GH Haewae Co. Ltd.

22 APRIL 2014

Observations Main Building 1

Tested Ground Floor Column – Stone Chips

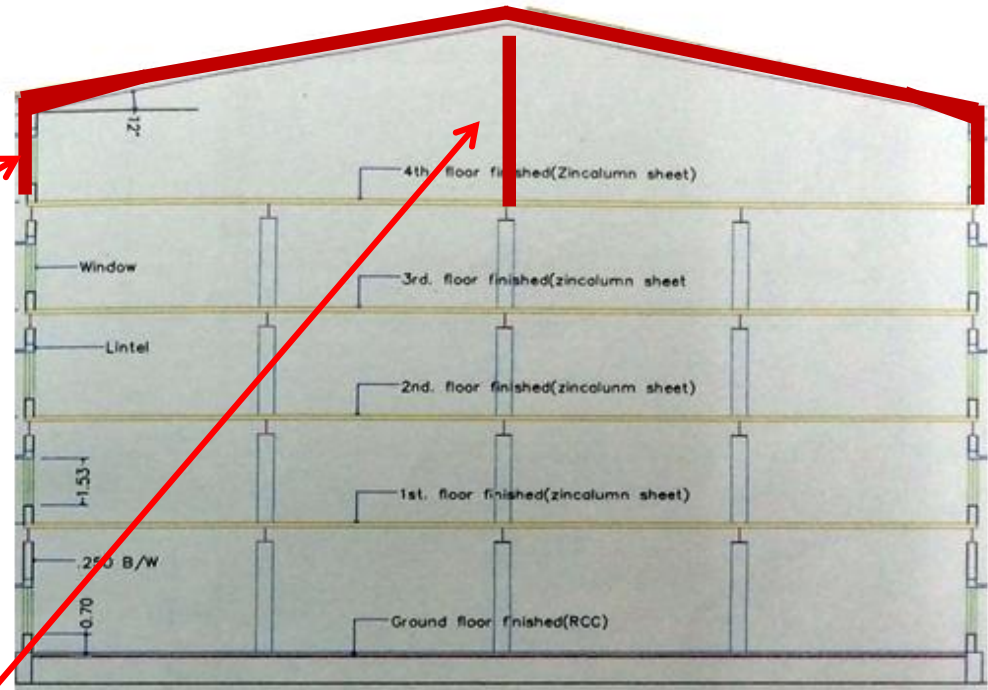
Column Strength

- No evidence of steel sections inside the columns.
- The corbel details supporting the primary steel beams indicate that the columns in the 5-storey building may well be just conventionally reinforced concrete columns.
- Ferro-scanning of the columns also indicated rebar inside rather than solid steel section.
- Outline check on column stresses based on concrete only and with a minimum reinforcement of 1.25%.
- Based on this, the columns under design loads (3kPa) would exceed the allowable stresses.
- A full Detail Engineering Assessment for Main Buildings 1 and 2 is strongly recommended including a thorough load-take down, core sampling and testing of the concrete in the columns, exposing of bars in some columns to establish the bar diameter and to establish the stress level.

Management of floor loads

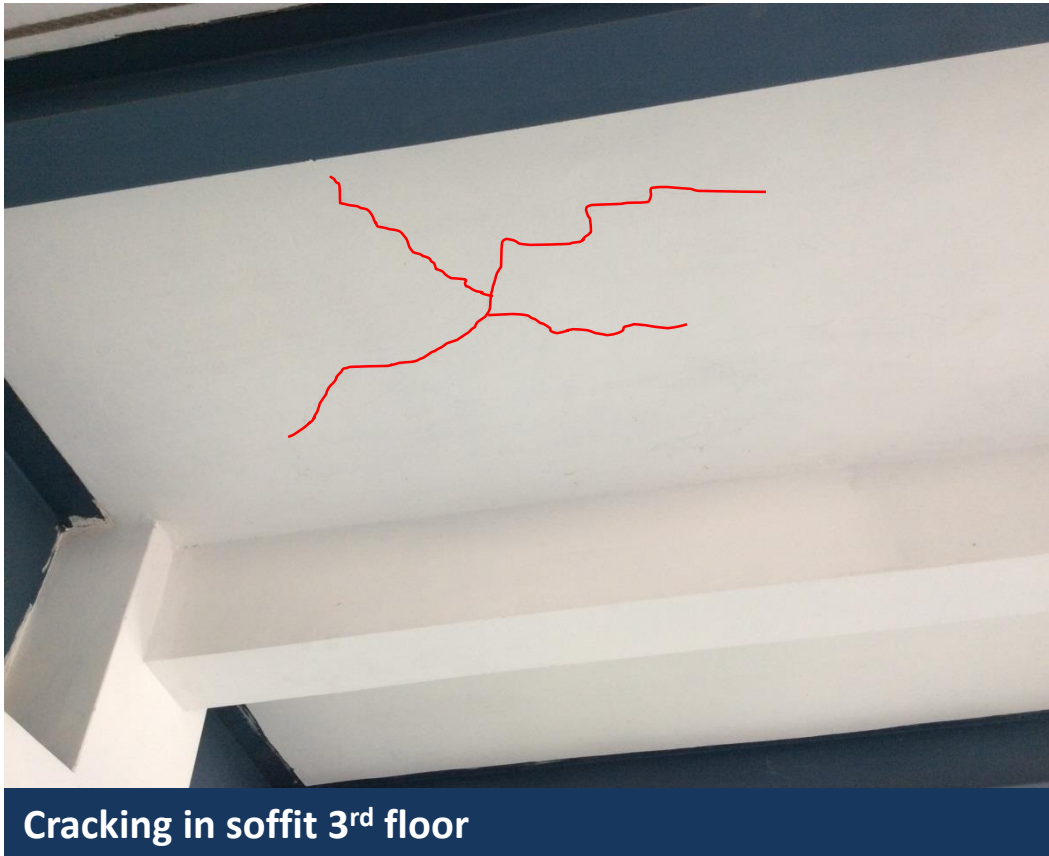
Storage load on 1st floor

Water tanks on roofs

RC water tank

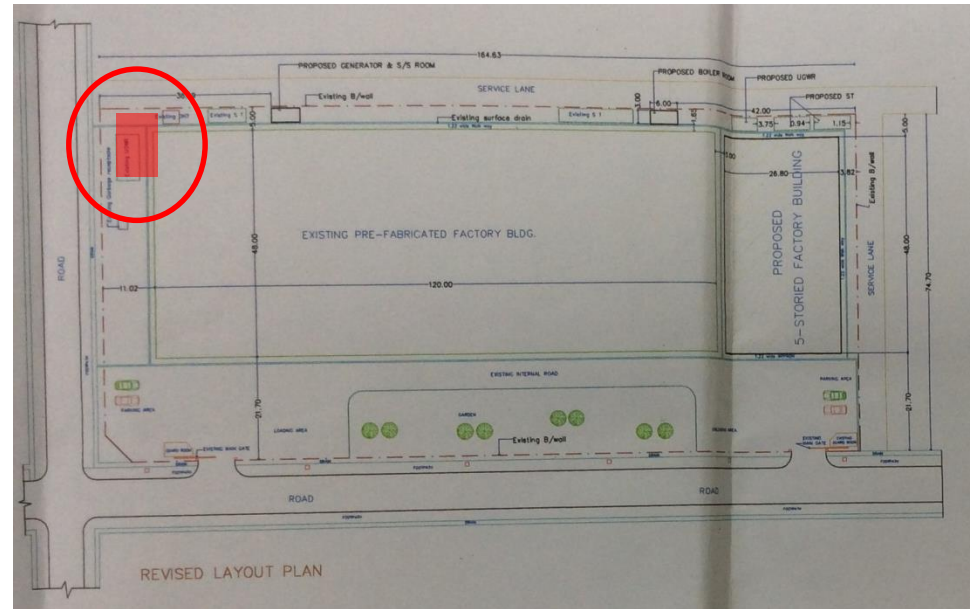
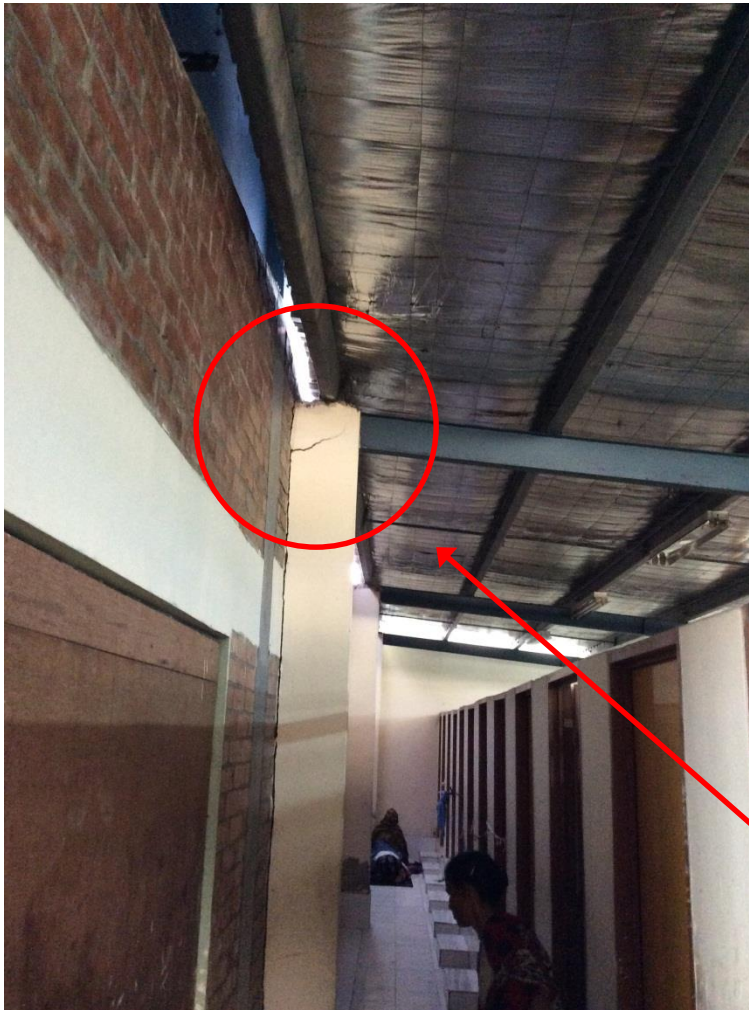
Damage on concrete water tank
and steel roof due to water leakage

Item No.	Observation	Recommended Action Plan	Recommended Timeline
9	Damaged structural elements supporting the high-level RC water tank outside the sewing shed.	Building Engineer to assess the structure supporting the water tanks.	Immediate - Now
10	Damaged structural elements supporting the high-level RC water tank outside the sewing shed.	Carry out all structural repairs to the support structure arising from engineering assessment.	6-weeks
11	Damaged structural elements supporting the high-level RC water tank outside the sewing shed.	Take measures to prevent any further damage to the support structure in the future.	6-months
12	Crack at the top of a concrete column in the women's toilet area (extension building to the 2-storey sewing shed at the far end / first floor level)	Building Engineer to assess beam/column connection and crack in column.	6-weeks
13	Crack at the top of a concrete column in the women's toilet area (extension building to the 2-storey sewing shed at the far end / first floor level)	Stability system of the extension building to be established as part of the Detail Engineering Assessment (see Item 6).	6-months

No clear movement joint

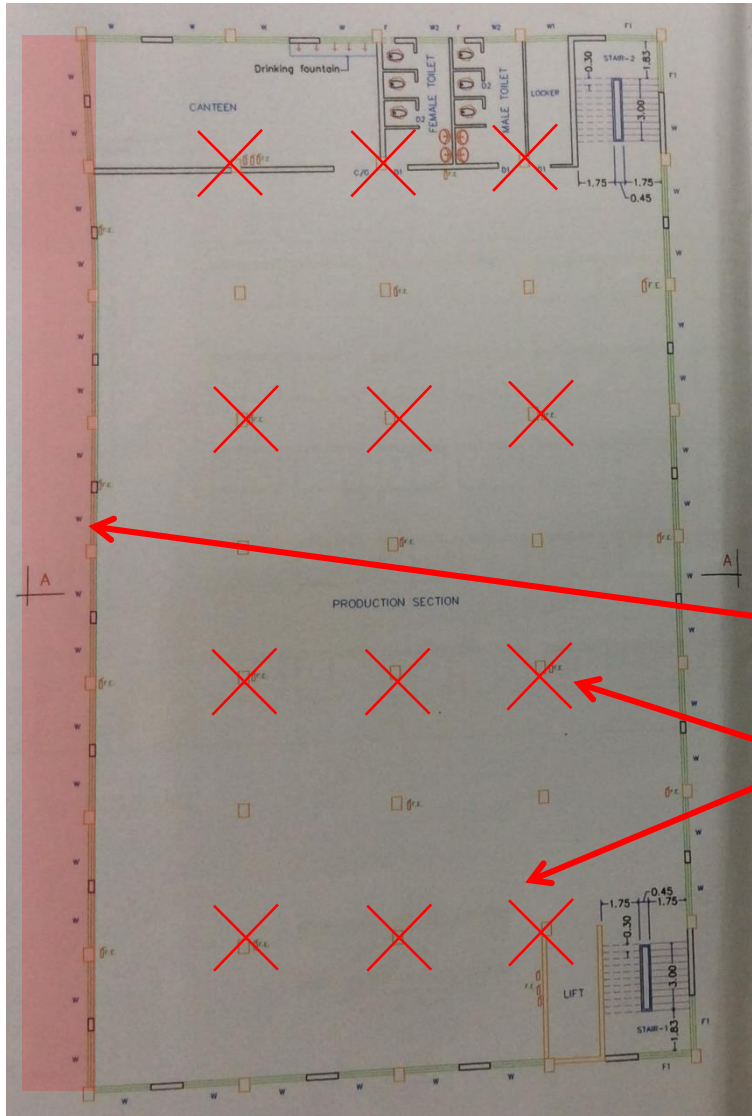
No visible movement joint between the two supposedly independent structures. The external brick wall provides stability in the longitudinal direction for both the roof and the 1st floor slab.

Centre column is used for both systems.

Roof and floor structure seem to have been deliberately separated from each other as the roof column runs passed the first floor. However, the two structures are not separated from each other everywhere, having bearing elements in common.
